Submission Objection

Response to (PJEP) Environmental Impact Statement – October 2024
In Reference to SSDA 64409468 (WSABP)

4 December 2024

The Landowner, Lot 8, DP1240511

Figure 2: Proposed placement of Collector Road

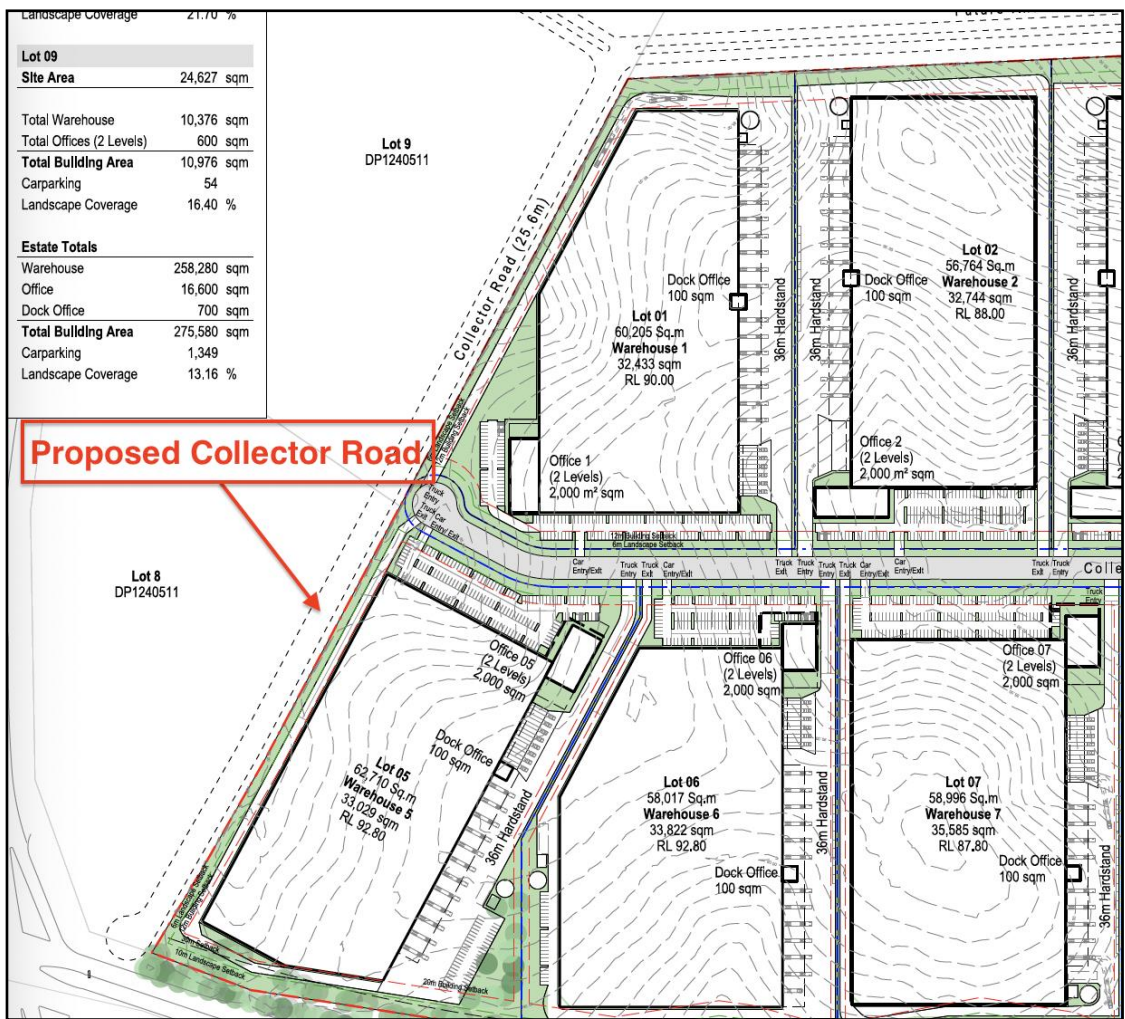
This submission outlines an objection to the **placement of the Collector Road**.

The proponent's decision to place the Collector Road entirely over the southern portion of Lot 8, instead of distributing the burden equitably along the common boundary. (See [Figure 2](#)).

This submission objects to the proponent's placement of the Collector Road over the southern portion of Lot 8 DP1240511.

The proposal disregards key principles of the Western Sydney Aerotropolis Precinct Plan (WSAPP), resulting in the unnecessary severance of Lot 8 and neighbouring properties to the east. The proponent's self-serving interpretation of the Precinct Plans unfairly shifts the burden of road construction and associated costs onto adjoining landowners.

The proposed road alignment must be redesigned to uphold the WSAPP's principles and objectives, ensuring equitable sharing of road development impacts across affected properties and preventing undue burden on Lot 8 and its similarly impacted eastern neighbours.

Figure 4: Excerpt from the EIS labelled "Figure 4.10", WSA Precinct Plan Transport Network

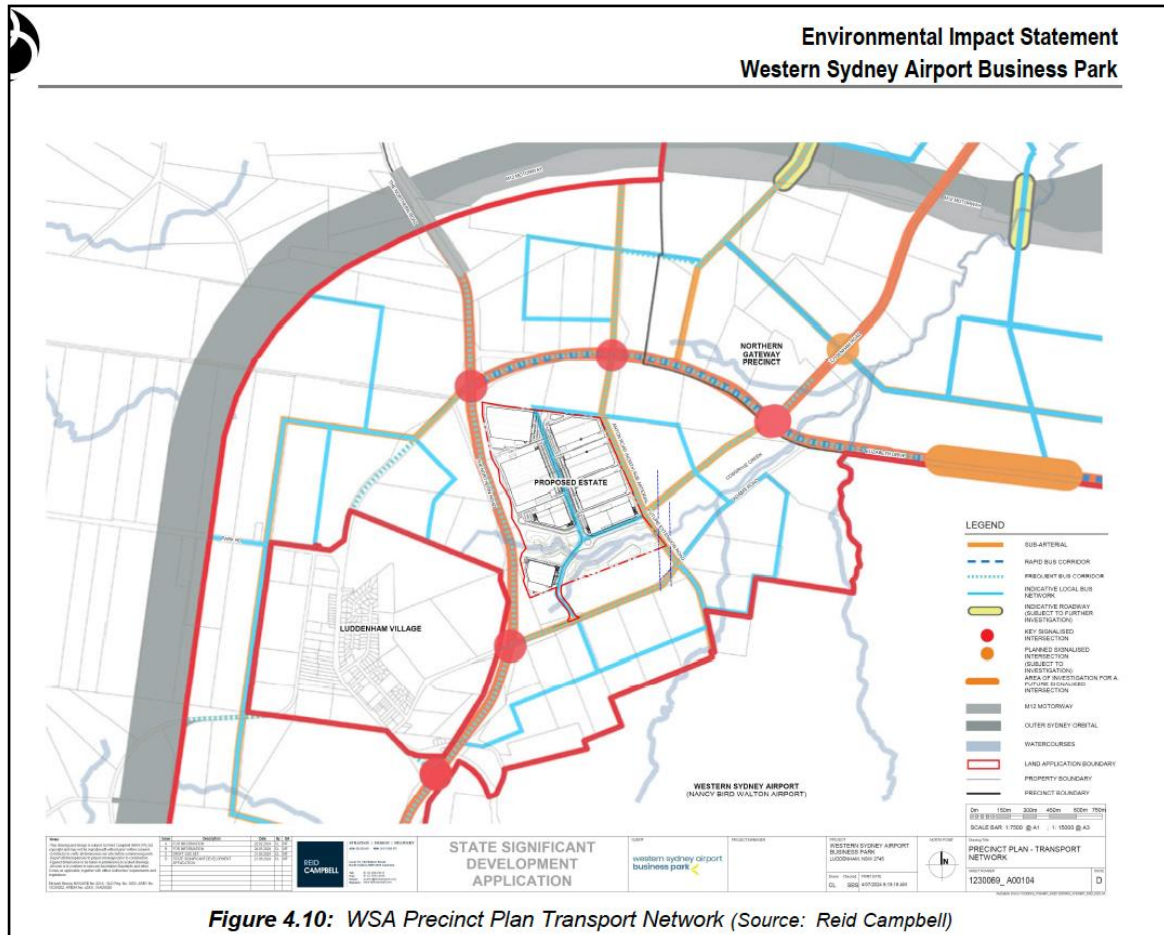
In Section 4.4 of the EIS, the proponent references Figures 4.9 to 4.11 (and Appendix C) as evidence of compliance with the WSAPP. Upon review, Figure 4.10 is the only relevant figure that could be interpreted as justifying the placement of the Collector Road over neighbouring properties. (See [Figure 4](#))

Figure 5: Excerpt from the EIS, "Appendix C"

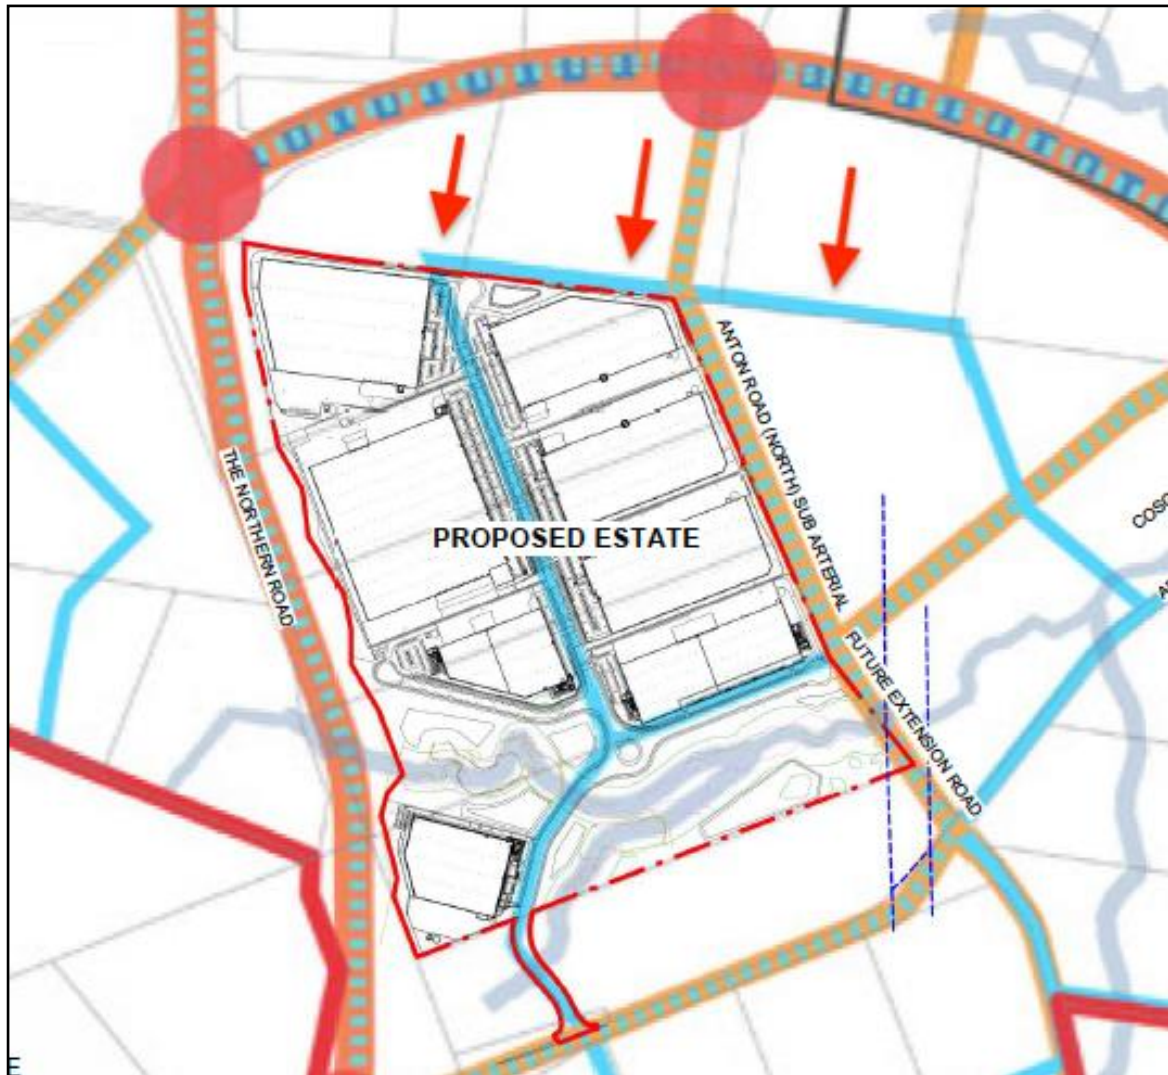
In Appendix C, the same indicative plan, sourced from the WSAPP, is used to support the alignment of the Collector Road over neighbouring properties to the north of the proposed development. Red arrows in [Figure 5](#) highlight the indicative layout on which the proponent relies.

Figure 11: Excerpt from September 2024 WSAPP, labelled “Figure 10”

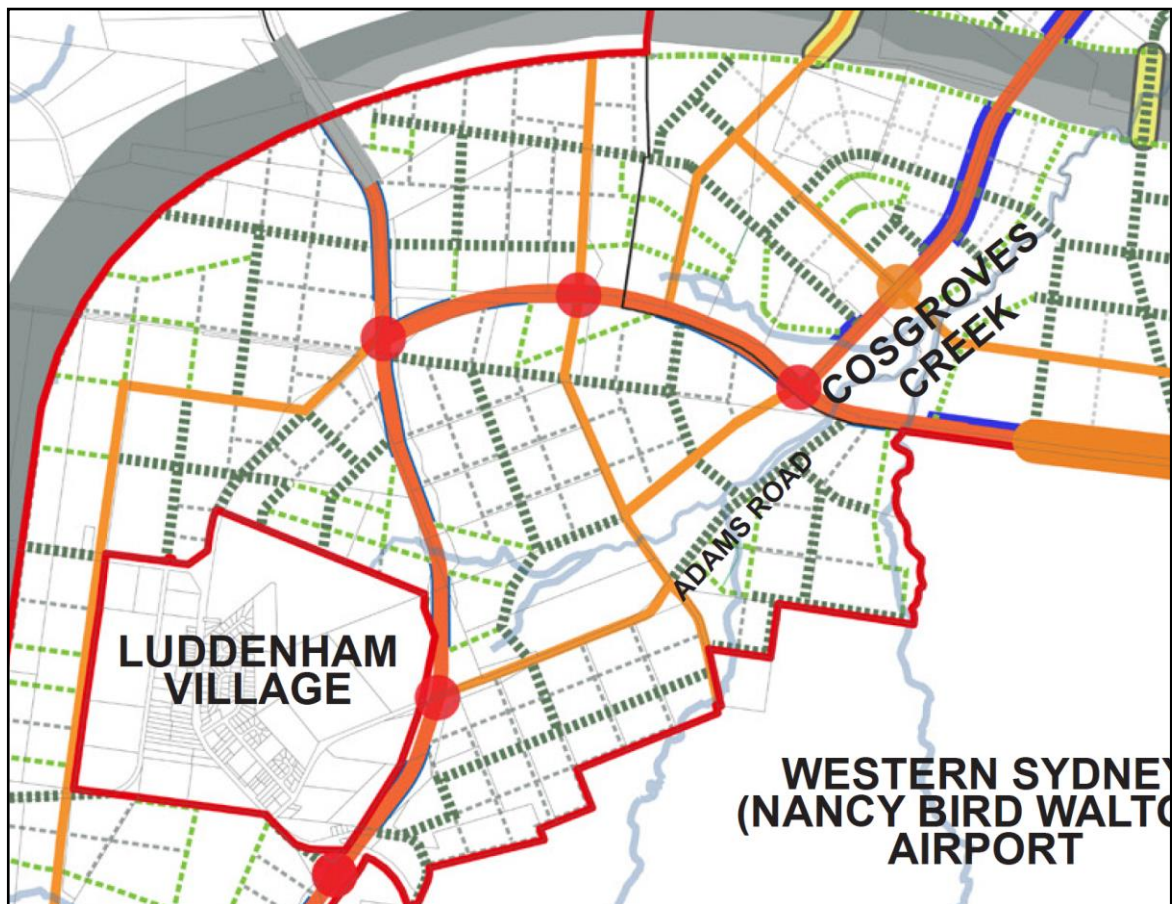
See below [Figure 11](#), an image taken from the WSAPP (as labelled 'Figure 10: Street Hierarchy') illustrates the “high-level detail” of the plans as exhibited, where roads and property boundaries are mostly indistinguishable. This was not considered problematic, as stakeholders were aware of the flexibility inherent in the WSAPP's approach.

Figure 12: GIS layers used to produce WSAPP

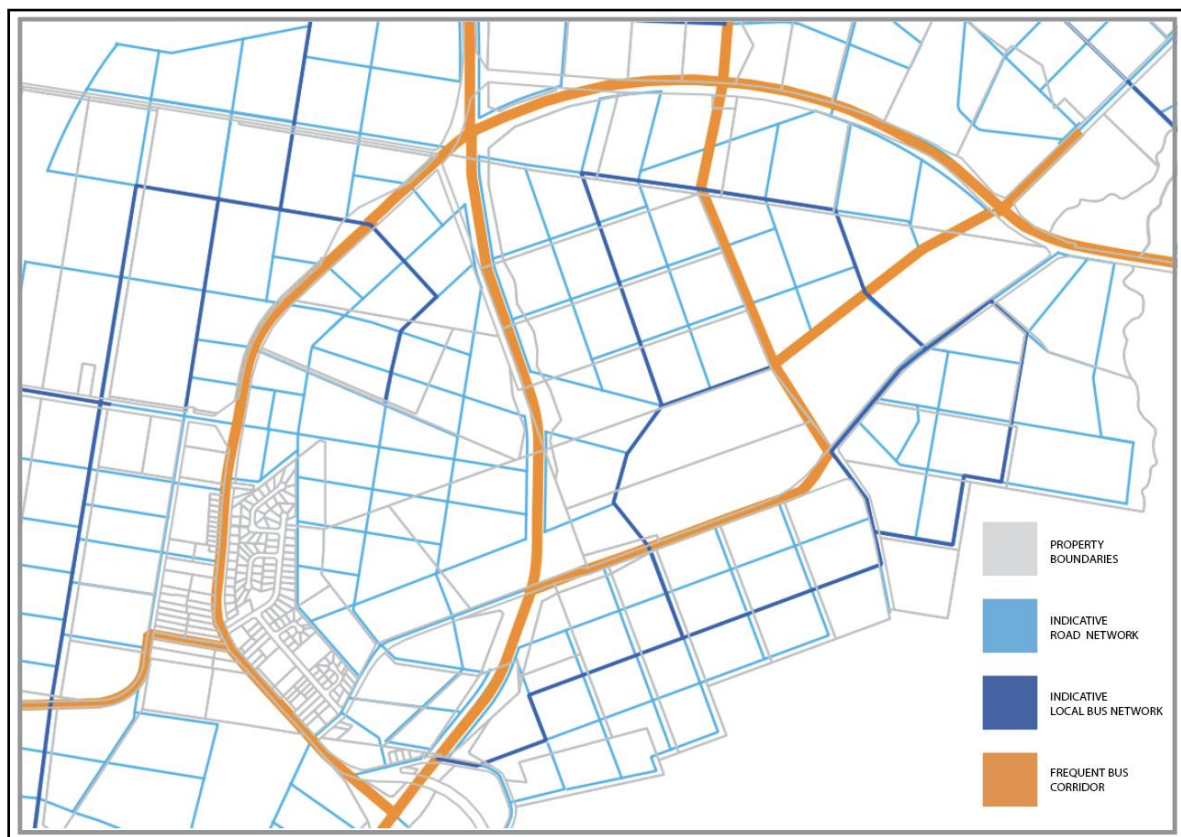
Although not publicly available or exhibited, the GIS layers used to produce the WSAPP plans reveal the preliminary nature of the road network framework. These layers highlight the obvious misalignment in the plans, further reinforcing the high-level, non-detailed nature of the exhibited plans.

The GIS layers shown in Figure 12 below, clearly reveal the mis-aligned framework used to produce the final WSAPP road network plans.
